| Project                      | IEEE 802.16 Broadband Wireless Access Working Group < <a href="http://ieee802.org/16">http://ieee802.org/16</a> >   |  |
| Title                        | Enhancements of Space-Time Codes for the OFDMA PHY  |  |
| Re:                          | 802.16e/D8  |  |
| Purpose                      | To propose enhancements of the Space-Time codes in 802.16e/D8.  |  |

Figure 1: Performance comparison (uncoded) for 4Tx-Rate 1 the current matrix A in the standard and the new proposed matrix A' in a flat Rayleigh fading channel with QPSK modulation.

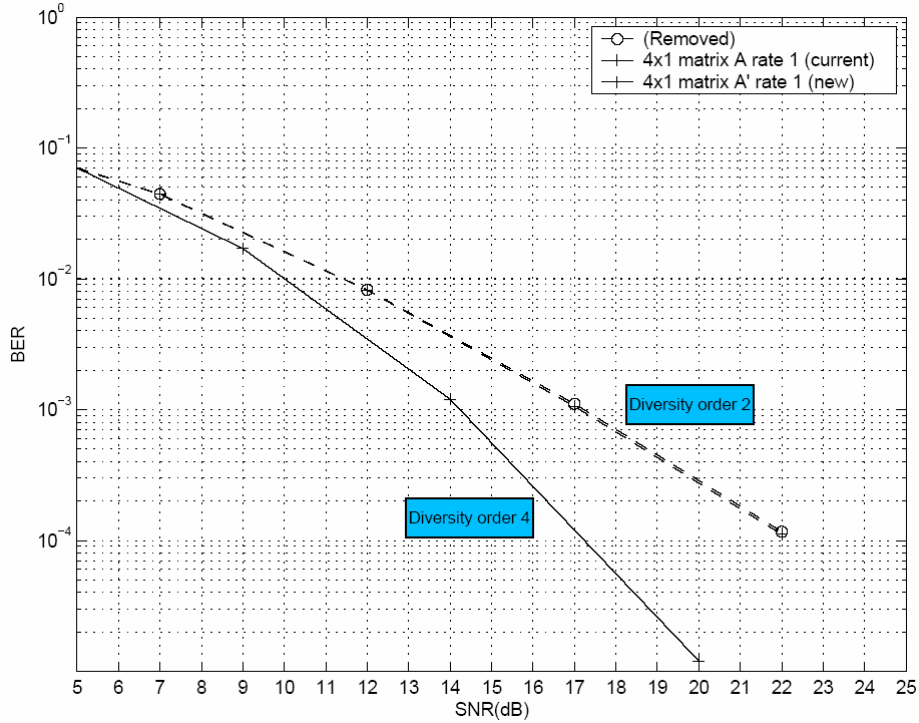
This proposed change is guided by the following reasons: (i) The transmit diversity gain of  $A'$  is 4 whereas that of  $A$  is only 2, (ii)  $A'$  admits a decoupled symbol-by-symbol decoding for the variables which leads to a fast ML decoding with a simple slicer (analogous to the Alamouti code for 2TX). Fig. 1 shows the performance of this code using decoupled ML decoding of low complexity for QPSK.

Figure 3: Performance comparison (uncoded) for the 4Tx-Rate 1 matrix B currently in the standard and the proposed matrix D for QPSK modulation in a flat Rayleigh fading channel with MSE type receivers.

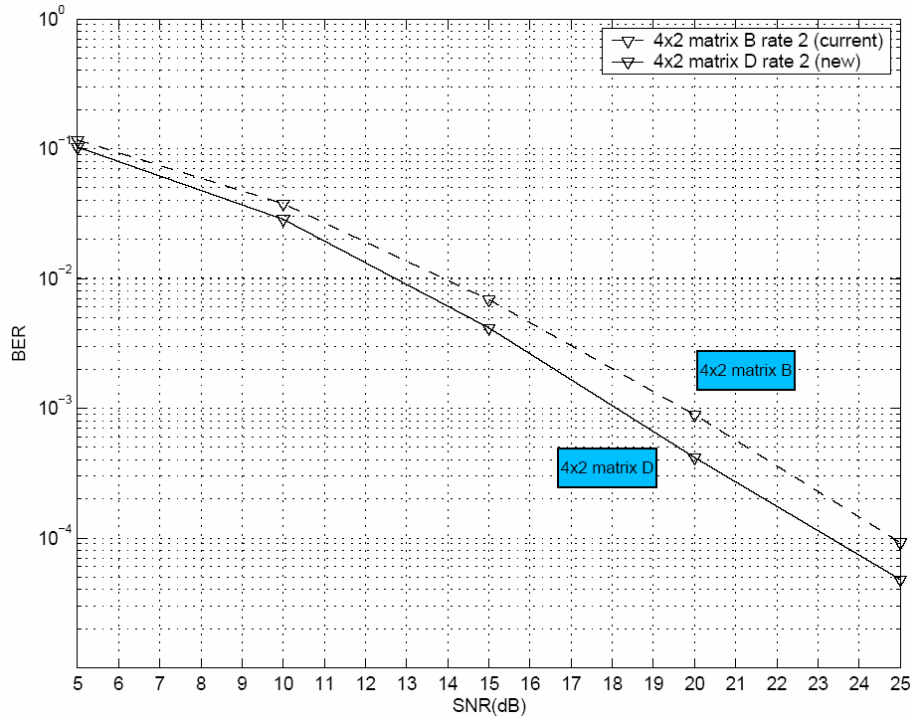
The proposed code gives more coding gain than the current transmission matrix B with MSE detection as shown in Figure 2.
